# 2020 Corvette: Service Bulletin:: #20-NA-179: Malfunction Indicator Lamp (MIL) Illuminated - DTCs P0521 and/or P06DD Set - (Oct 23, 2020)

**Subject:** Malfunction Indicator Lamp (MIL) Illuminated – DTCs P0521 and/or P06DD Set

Brand:	Model:	Model Year:		VIN Breakpoint:		Engine:	Transmission:
		from	to	from	to		
Chevrolet	Corvette	2020	2020	SORP	September 10, 2020	6.2L (LT2)	—

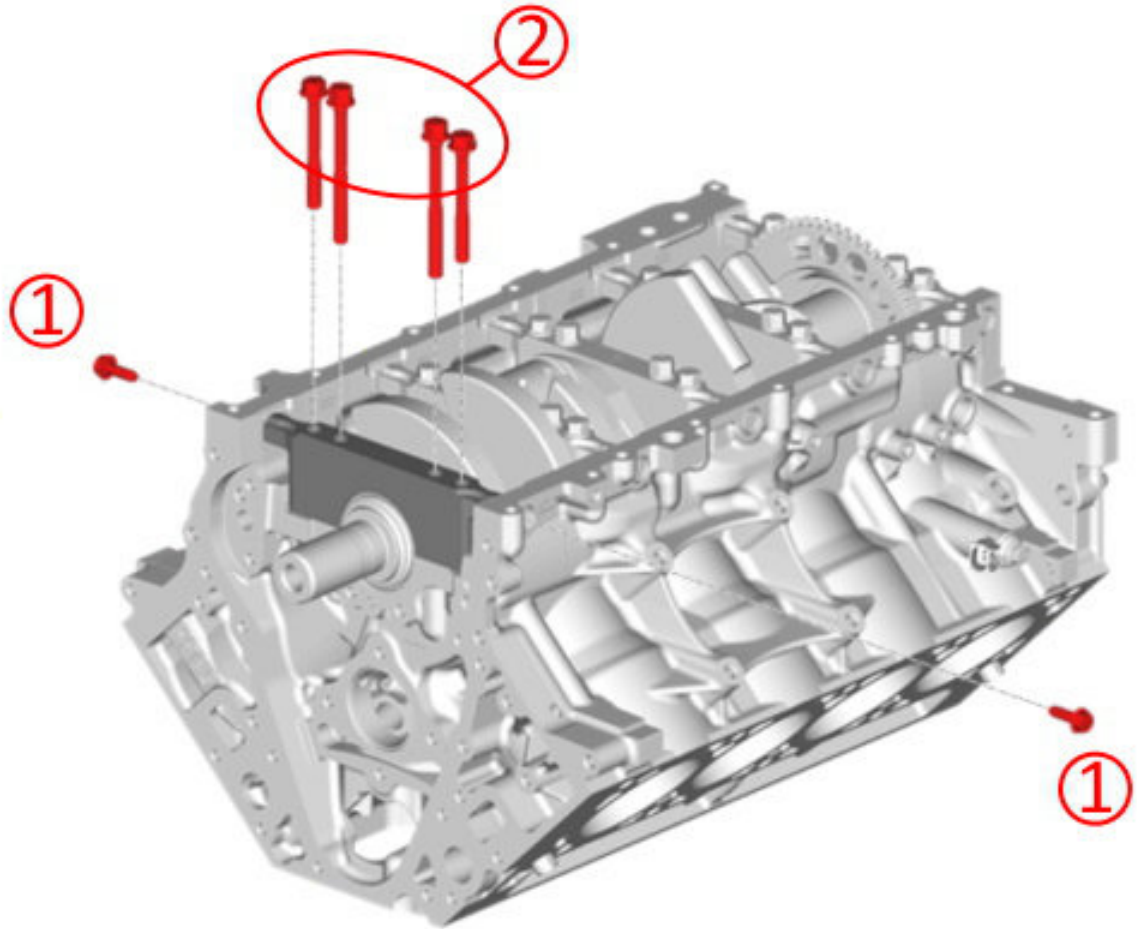
This condition may be caused by an unseated engine oil pressure control valve (OCV).

If P0521 and P06DD DTCs are present, then a redesigned oil pressure control valve retainer clip (1) may be necessary. Refer to the Service Procedure section below.

**Note:** If a vehicle comes in with one of these DTCs, follow SI for both DTCs to ensure there is not an electrical fault or other hardware concern. After diagnosis has been performed and no issues are found electrically, then it will be necessary to remove the engine oil pan and inspect for a unseated engine oil pressure control valve, which is mounted on the bottom of the engine oil pump.

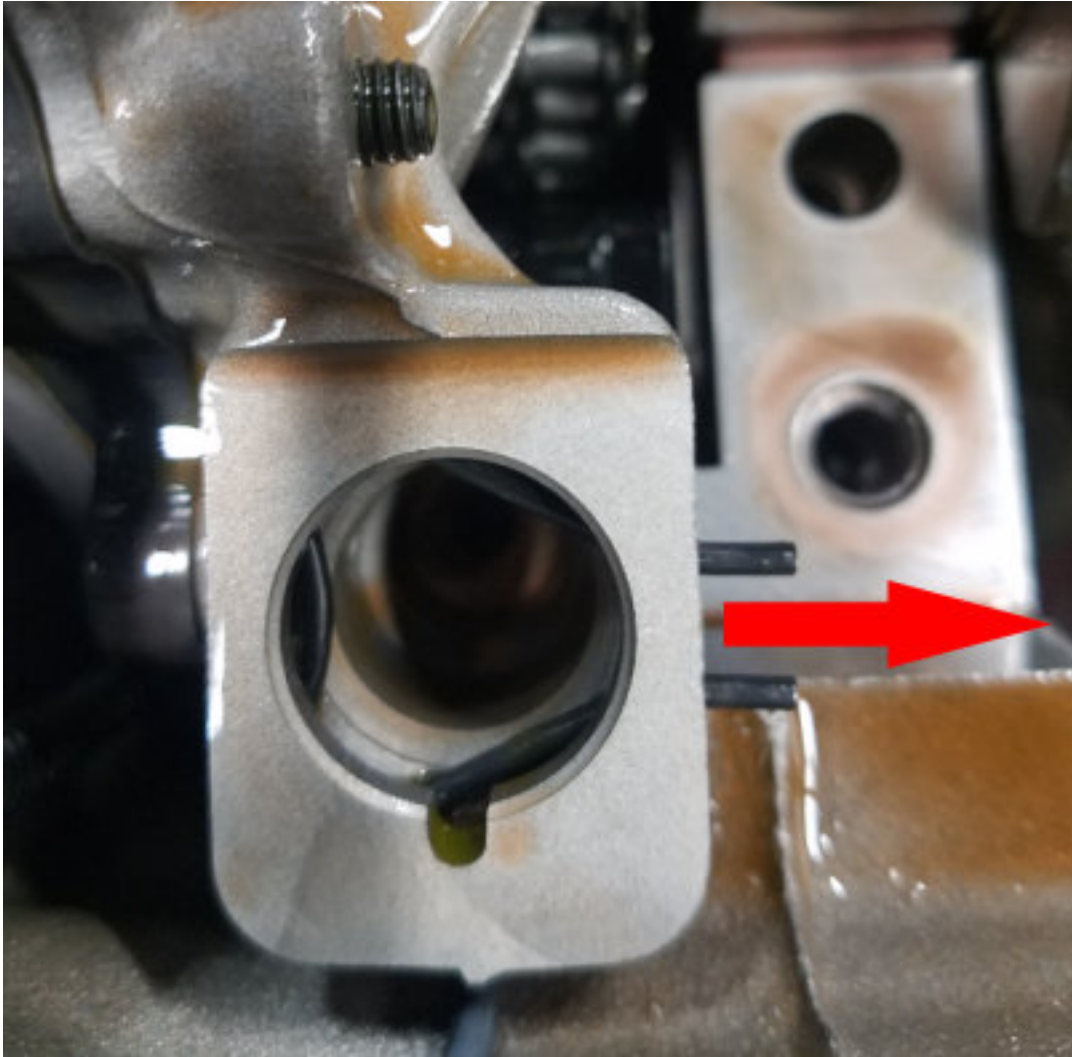
1. Inspect the OCV:
  - If you find this oil pressure control valve dislodged (1), it will be necessary to install a redesigned oil control valve retainer.
- Disconnect the oil pressure control valve electrical connector and position aside.

**Note:** Remove the existing oil pressure control valve retainer by pulling towards the rear and discard. You will be installing a newly designed retainer during installation.

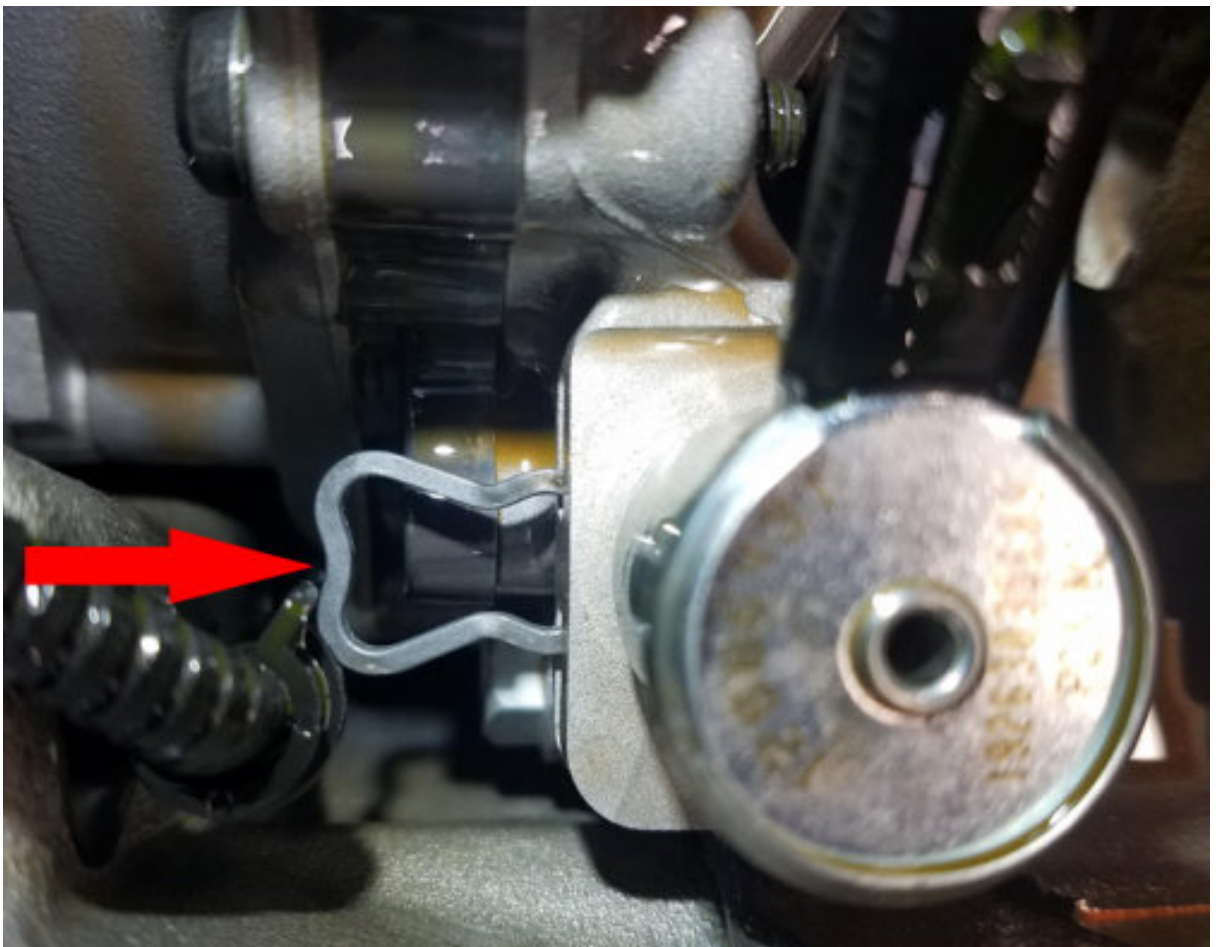
1. Install the new retainer from the front of engine towards the rear as shown in the graphic above.

1. When the retainer is installed, there should be about 2 to 3 mm of clearance between the retainer and the oil pump body as shown above.

1. Push in the retainer and remove the oil pressure control valve and set aside.
  2. Once the retainer is removed, inspect the oil pressure control valve for any signs of damage and ensure the O-ring is not cut.
- Apply a small amount of clean engine oil to the pressure control valve and reinstall ensuring it is seated correctly.

**Important:** Do not use any tools to tap the pressure control valve into place. Only install the pressure control valve by pushing on the body of the valve by hand.
